Licence Number L6420/1988/14

Licence Holder Kalgoorlie Consolidated Gold Mines Pty Ltd

Premises Fimiston Plant and Tailings Storage Facilities
Mining Tenements G26/15, G26/44-68, G26/70-71,
G26/73-78, G26/82-86, G26/99-107, G26/138-145,
G26/149, G26/159, G26/160, G26/165, G26/166,
L26/267, M26/46, M26/78, M26/86, M26/95, M26/267-
268, M26/294, M26/308, M26/326, M26/359, M26/377,
M26/383, M26/405, M26/448, M26/451 and M26/715
KALGOORLIE WA 6430

Amendment

Figure 3: Summary of modelled seepage flux through base of TSF (Golder 2018)

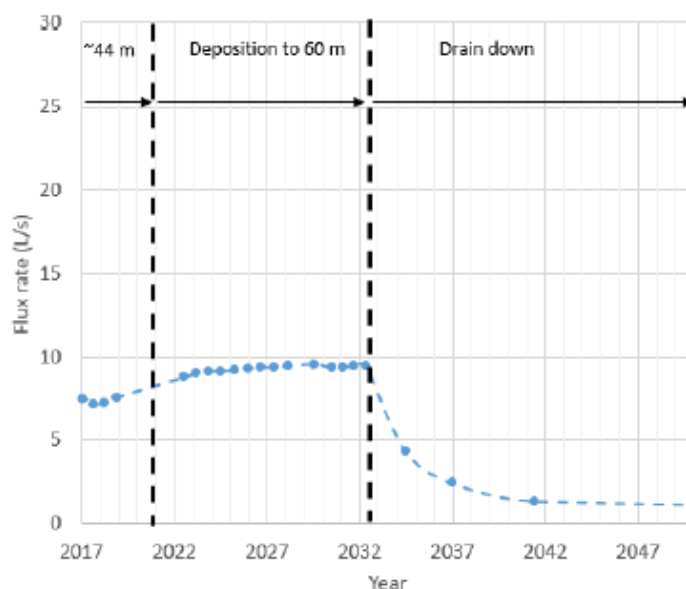
A review of the potential seepage impacts from tailings deposition to Kaltails TSF to a height of 60m has been completed by both the TSF Designer (Golder 2018) and the hydrogeological consultant (BDH 2018a). The seepage analysis completed by Golder indicates that the seepage rates are not expected to vary significantly from the current rates of approximately ~10L/s, with a maximum rate of up to 25 L/s. Refer to Figure 3 below.

Figure 4: Predicted groundwater elevation at downstream toe (adjacent to MB K43) (Golder 2018)

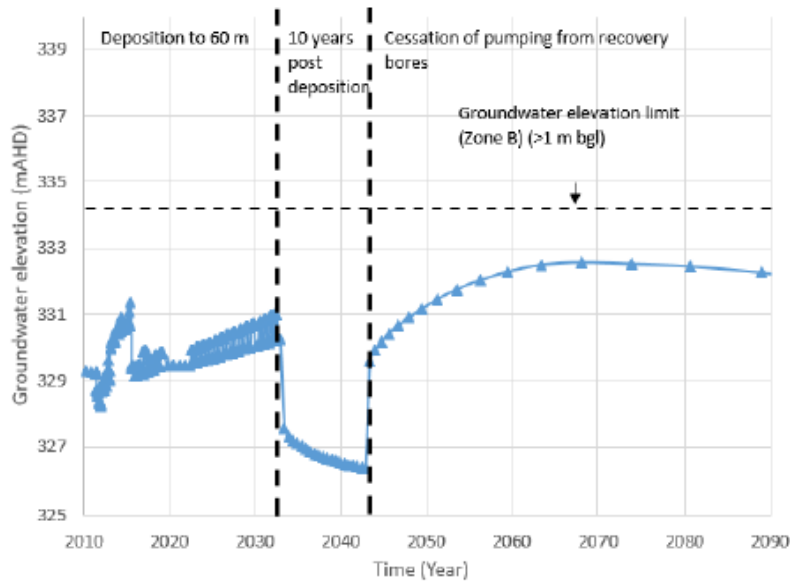
The model anticipates that the 1 mbgl limit in Zone B can be met at all times during deposition and at closure. The closure plan allows for 10 years of groundwater abstraction post closure in order to reduce the risk of vegetation rootzone inundation. Predicted groundwater elevations are shown in Figure 4 below:

The hydrogeological consultant's review (BDH 2018a) of the impact of the proposed height increase to 60m noted that there was potential for the 1 mbgl Zone B limit to be breached dependent on rainfall recharge and operational constraints (for example during processing plant shut-downs), however careful management of the production bores and response to groundwater data should ensure that the Kaltails Seepage and Groundwater Management Plan (KSGMP) remained effective to meet the groundwater limits for the facility.

Figure 5: Typical embankment sections with Phase 1 butress and embankment raise details (Golder 2018)

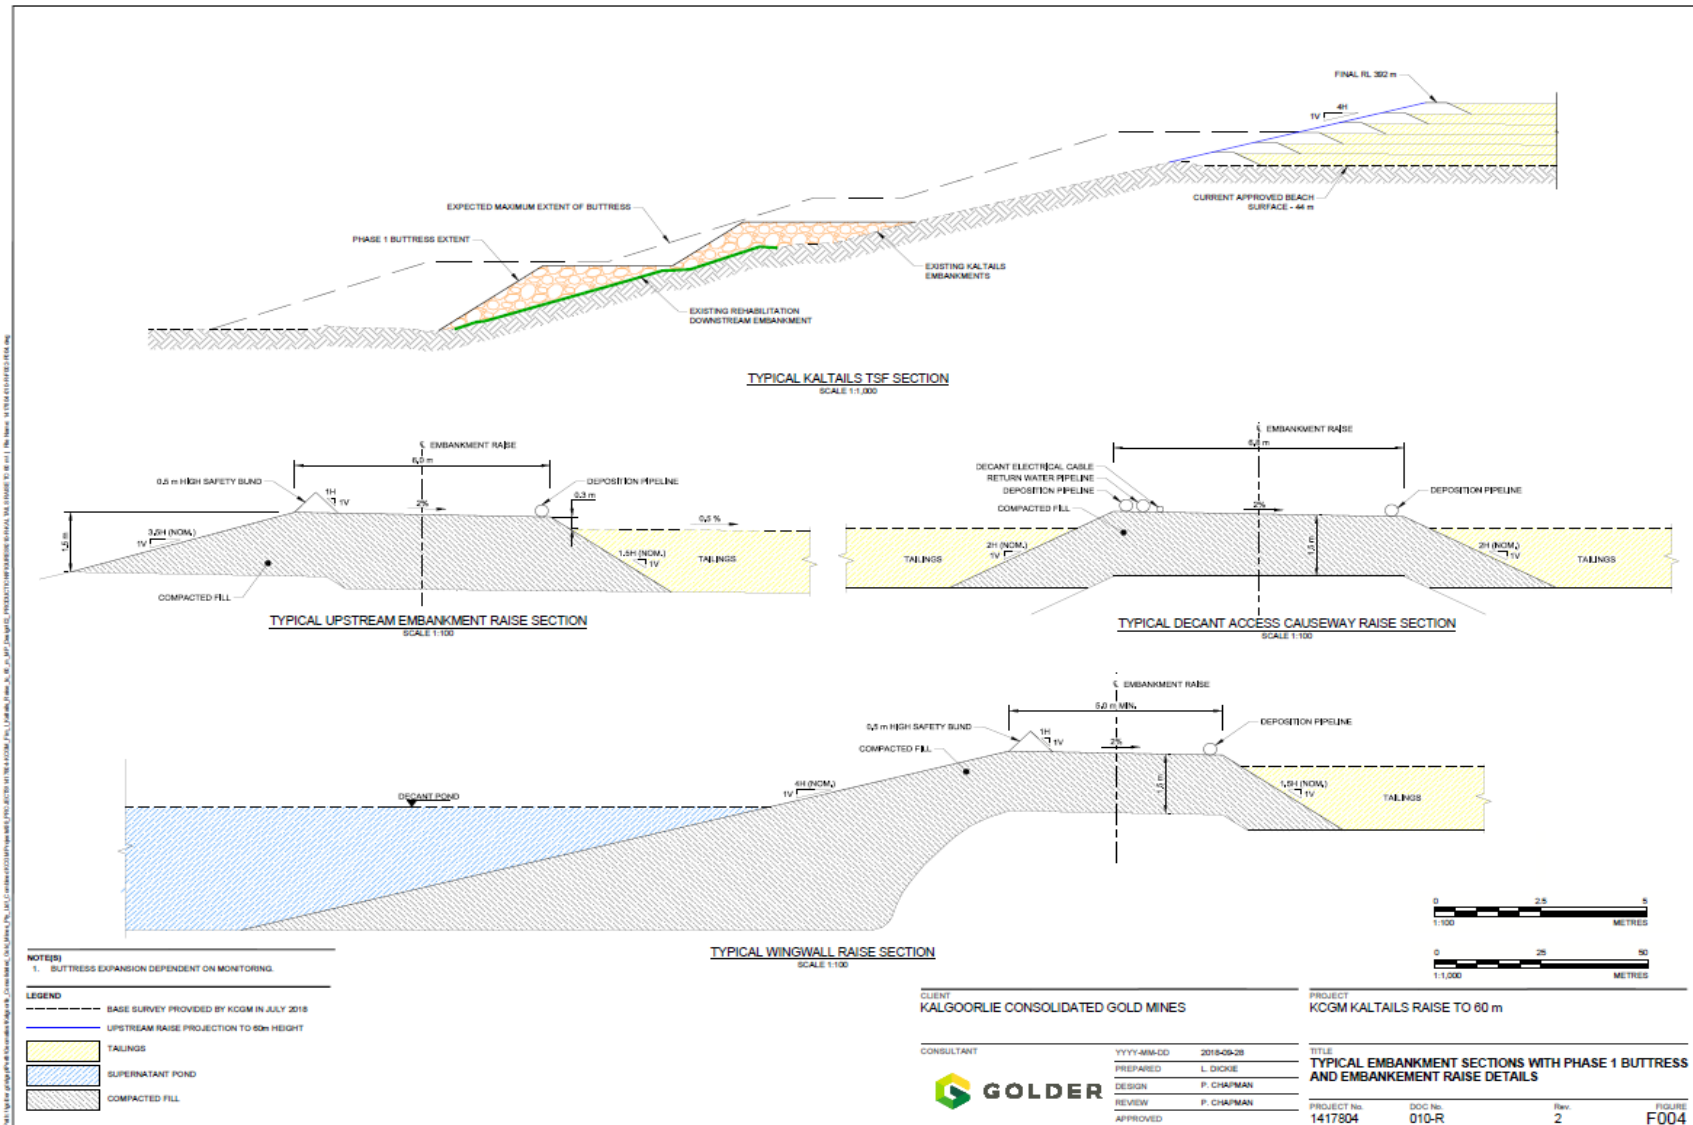
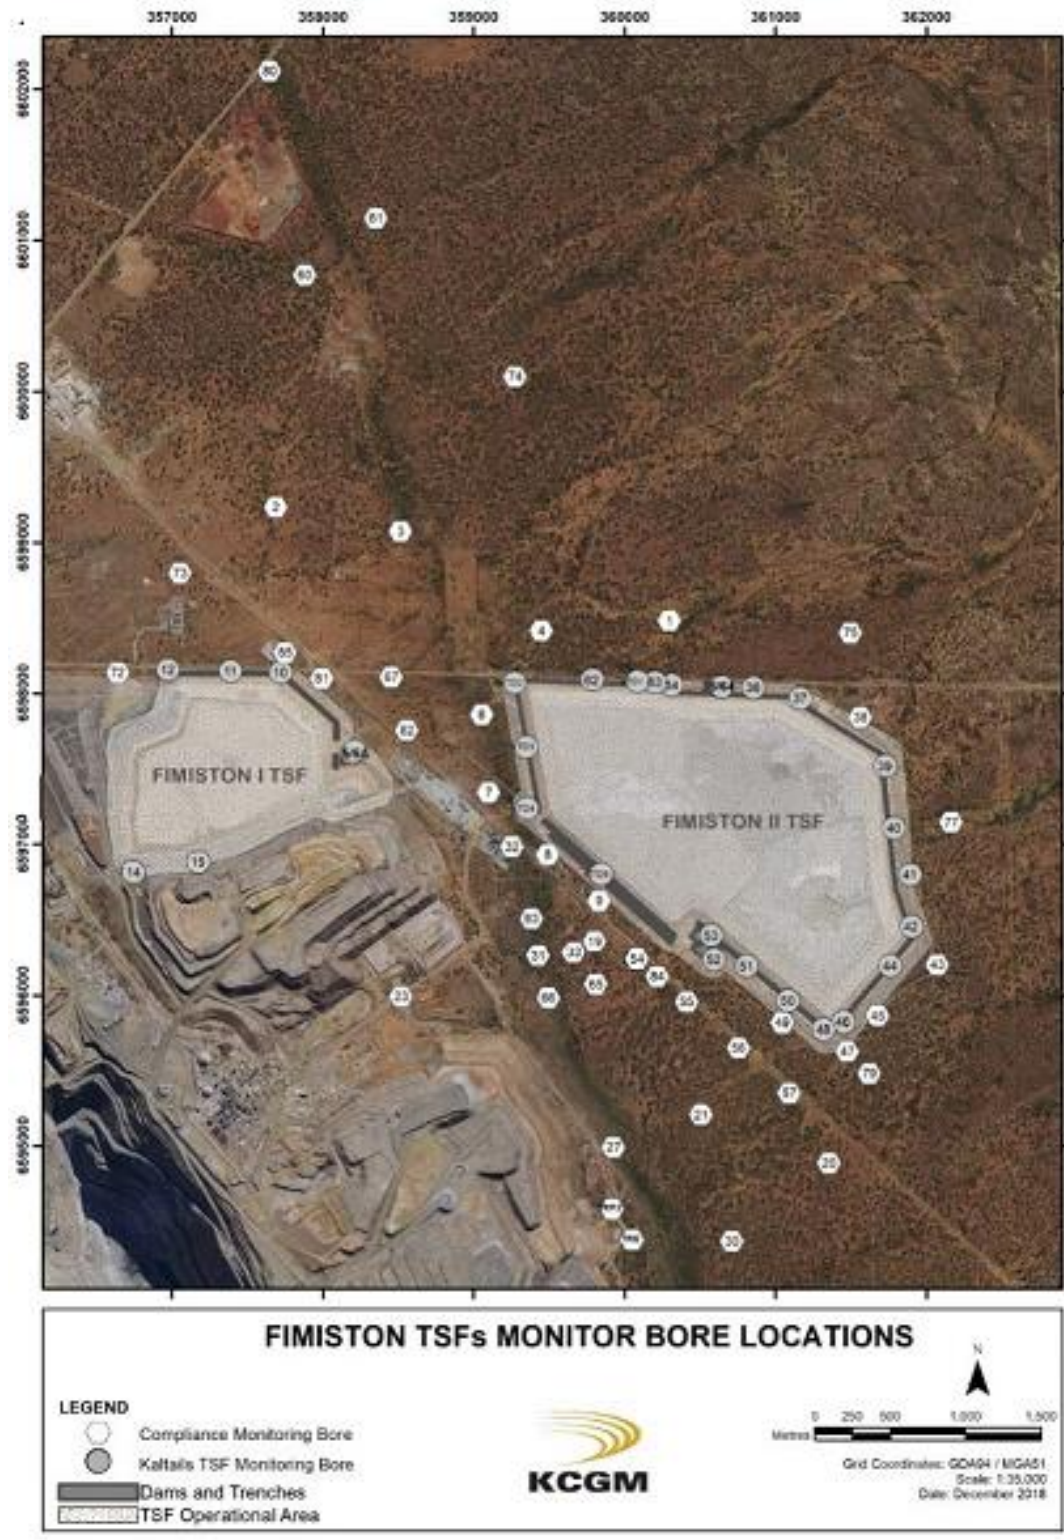
4. The Licence is amended by the insertion of the following Condition 1.3.17:

1.3.17 The Licensee shall ensure that the embankment raises' infrastructure specified in column 1 of Table 1.3.10 is constructed in accordance with the requirements specified in column 2 of Table 1.3.10.

Table 1.3.10: Construction of Kaltails TSF Embankment Raises	
Column 1	Column 2
Infrastructure	Requirements
Upstream perimeter embankment raises	<ul style="list-style-type: none"> In accordance with the Fimiston Mill Tailings Operating Manual (Golder 2013, and subsequent revisions). Typical embankment section as per Figure 5 (Golder 2018 Figure F004) below. Construction to be supervised by an engineering or geotechnical specialist.
Decant tower and access causeway	Relocate the decant tower and causeway. Typical decant causeway raise section as shown in Figure 5 (Golder 2018 Figure F004) below.
Areas subject to construction activities	Control dust by using water carts to wet down work areas.
